Registry No. H12144

Descriptive Report to Accompany Hydrographic Survey H12144

Project OPR-O351-FA-09

Revisions and Corrections Compiled During Office Processing and Certification

Figure 2: Crossline and main scheme differences (light pink indicates agreement with main scheme lines; dark pink/red indicates greater differences).

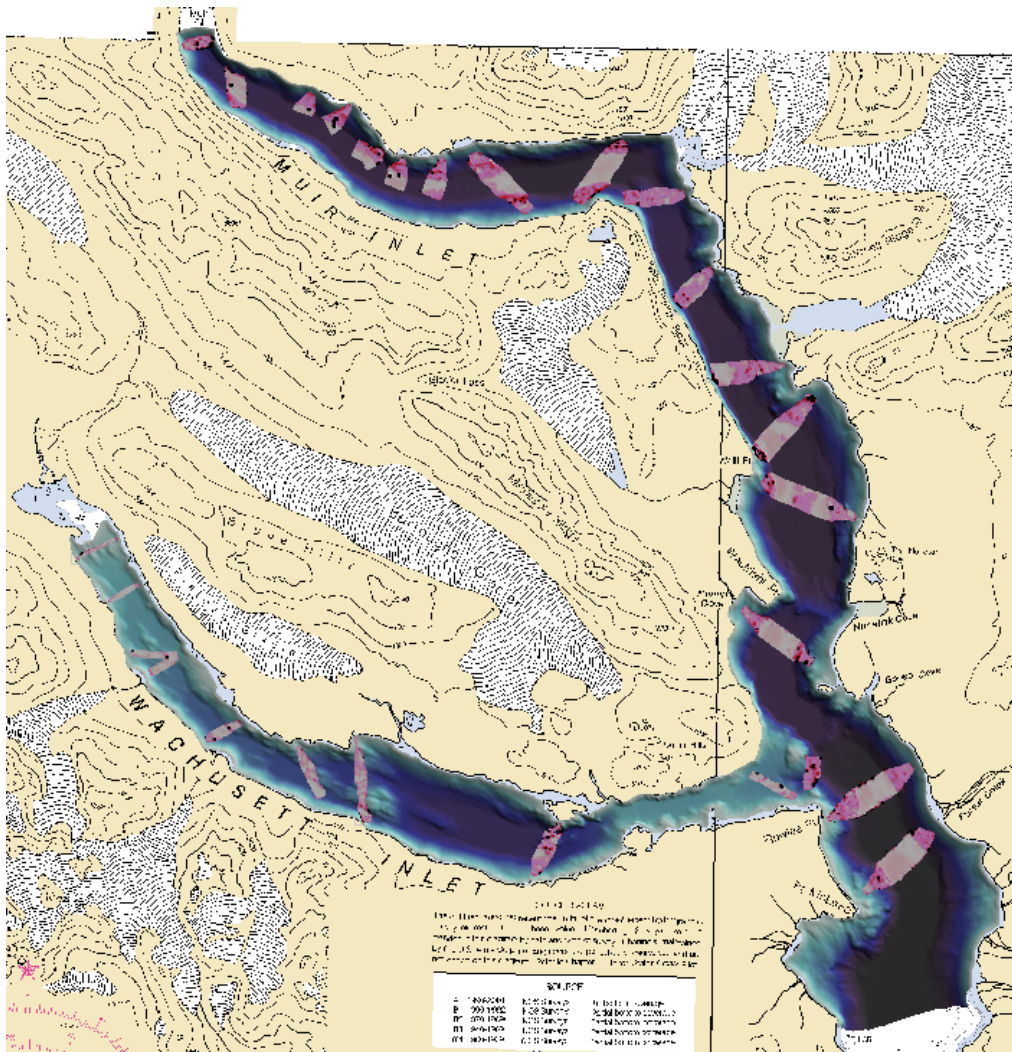
Surface differencing in CARIS Bathy Database was used to assess crossline agreement with main scheme lines. Figure 2 shows a visual depiction of the differences spatially. While the mainscheme and crossline surfaces tend to agree, the most significant differences are noted in the the most steeply sloping portion of the survey area along the inlet walls.¹

¹ Concur. Higher differences in areas of steep sloping bottom topography is expected and has been deemed acceptable.

Figure 11: Shoaling at Extent of Muir Inlet.

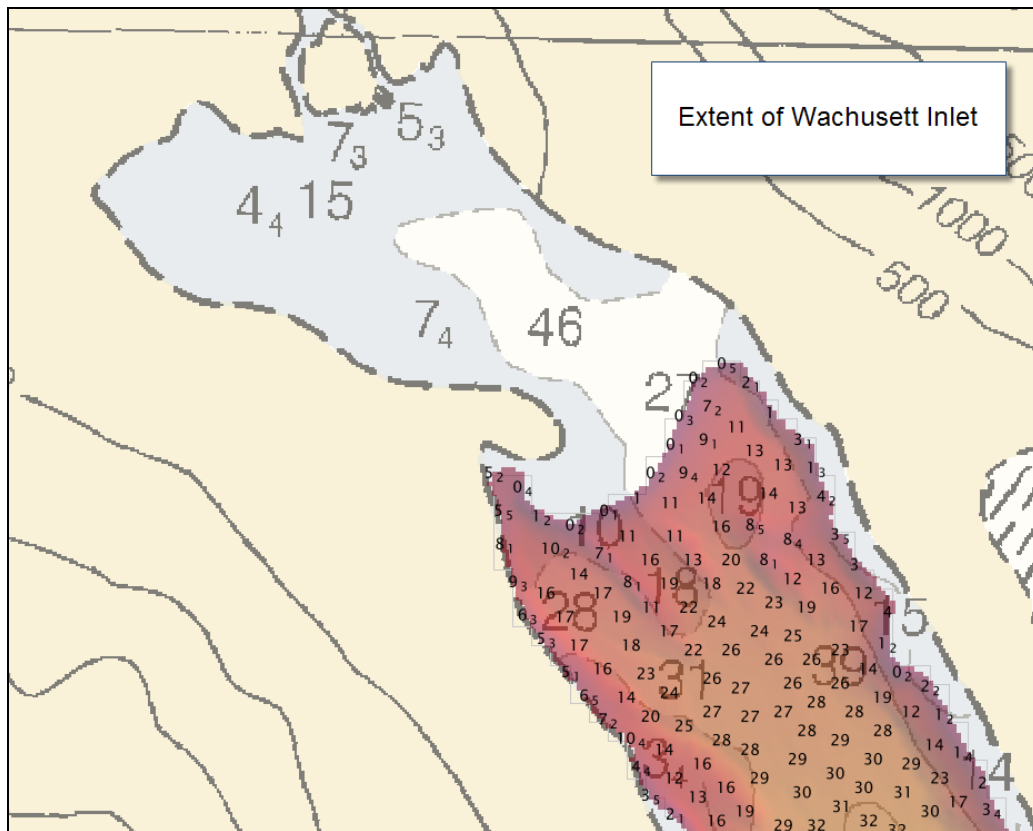
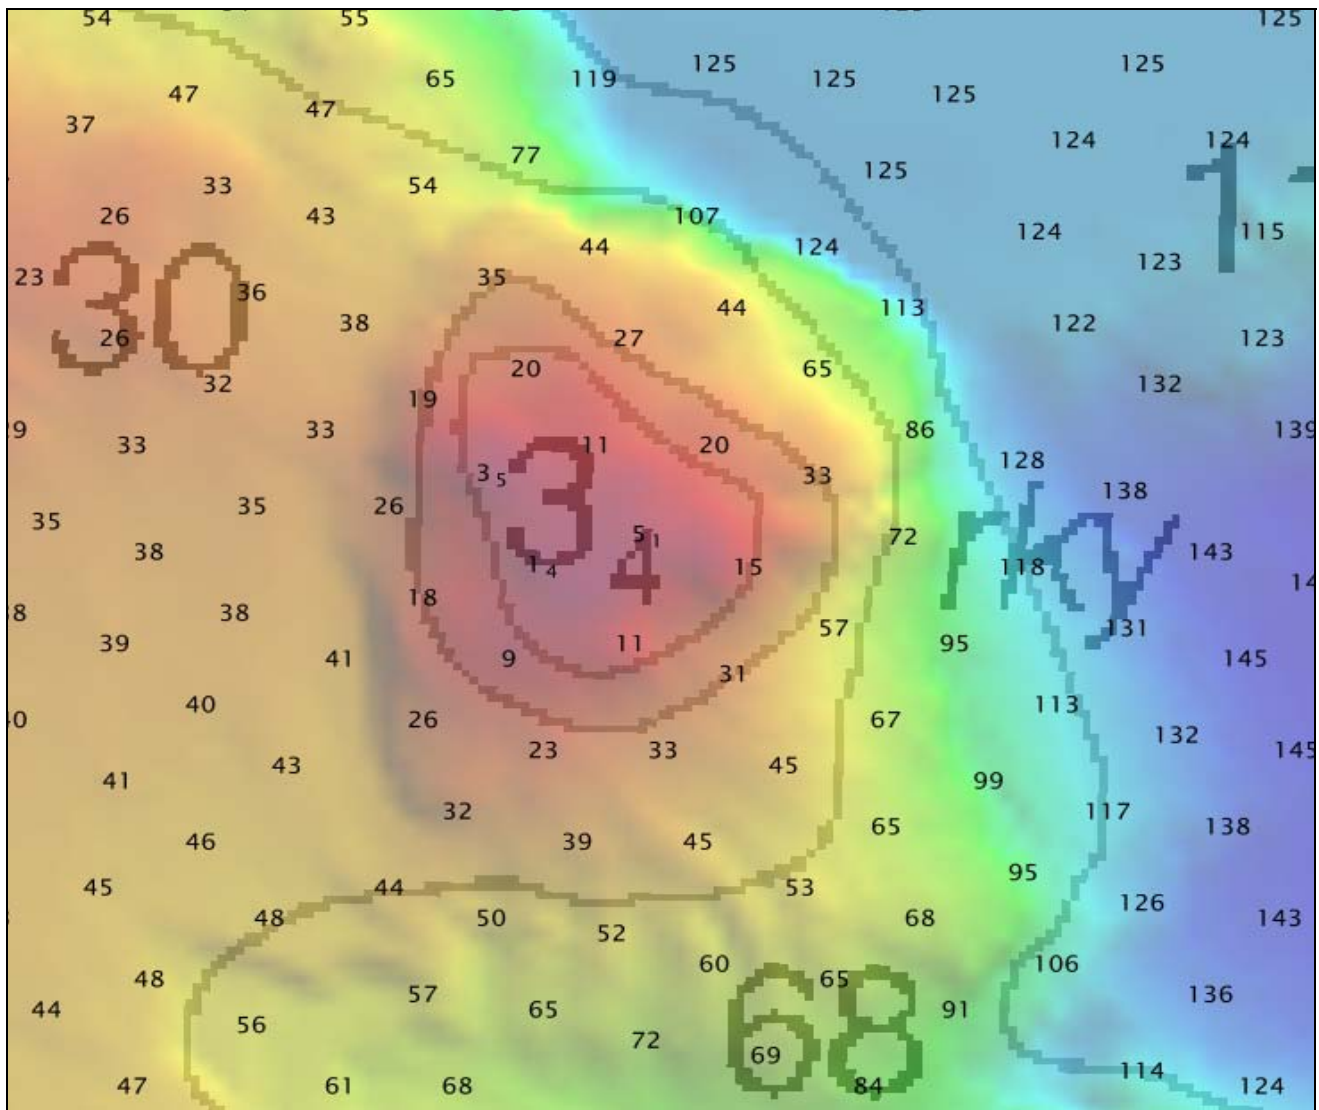
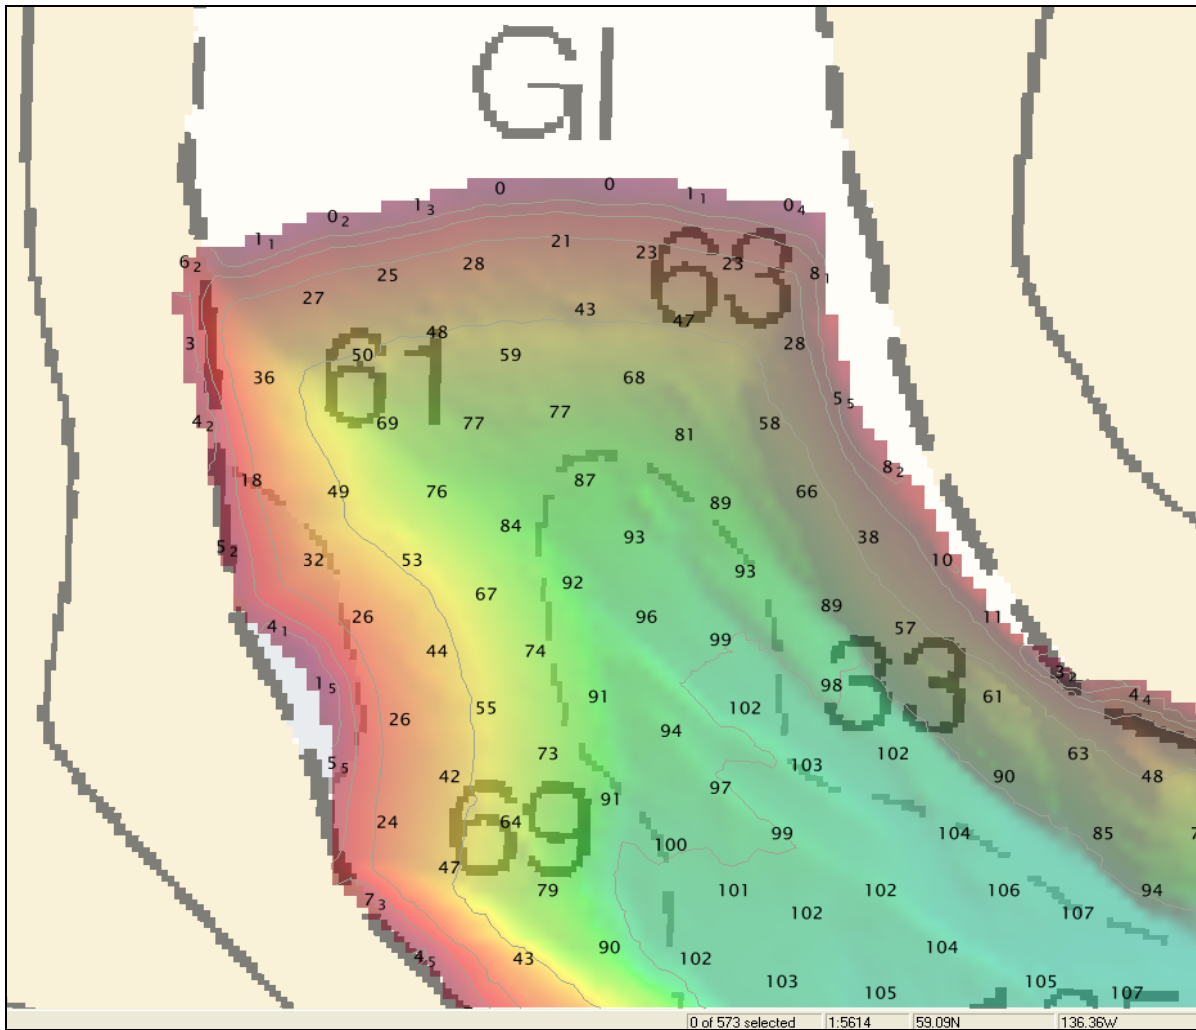
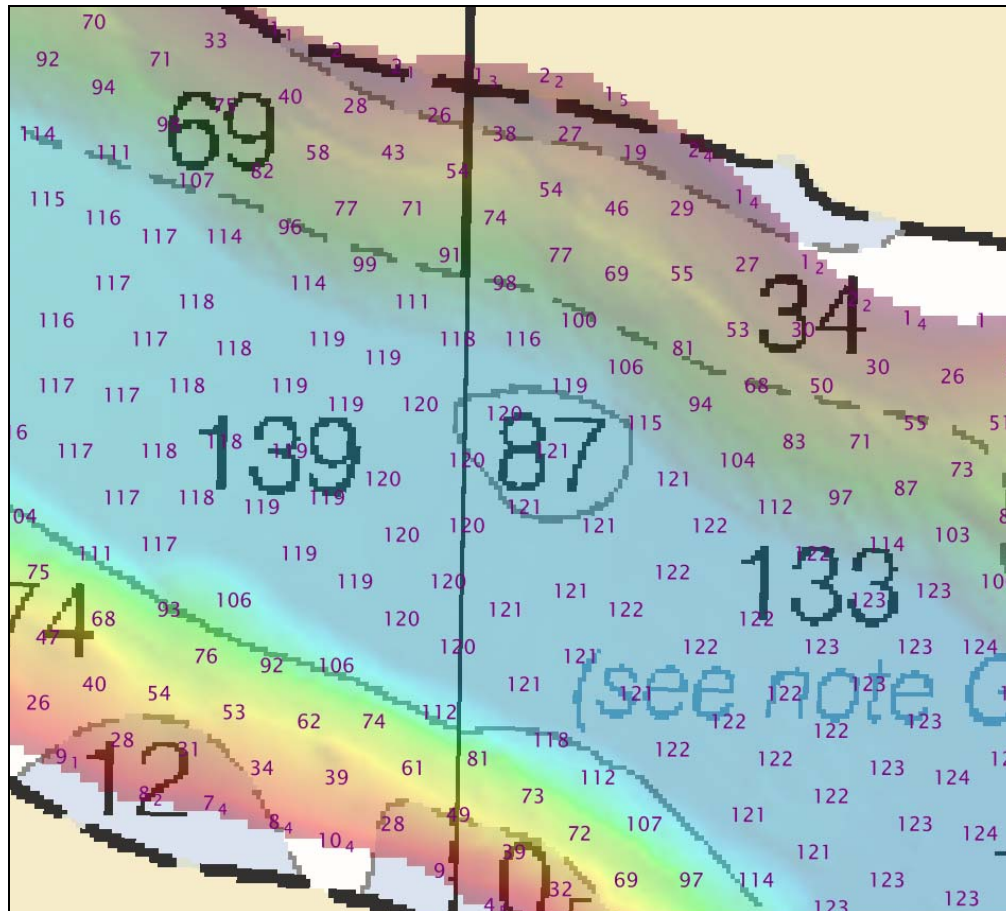
Soundings from survey H12144 generally agree within one to two fathoms with depths on chart 17318.¹⁸ Charted depths at and near the extents of Muir Inlet and, particularly, Wachusett Inlet, differ greatly with surveyed depths. As previously noted, significant shoaling has occurred at the extent of Wachusett Inlet, due to the accumulation of sediment from the inflow of glacial melt-water. A shoal point near the entrance to Wachusett Inlet (see figure 12) has decreased in depth from 3 fathoms, 4 feet and 1 fathom, 4 feet.¹⁹

¹⁹ Concur. Chart shoaler depths as depicted in the HCell.
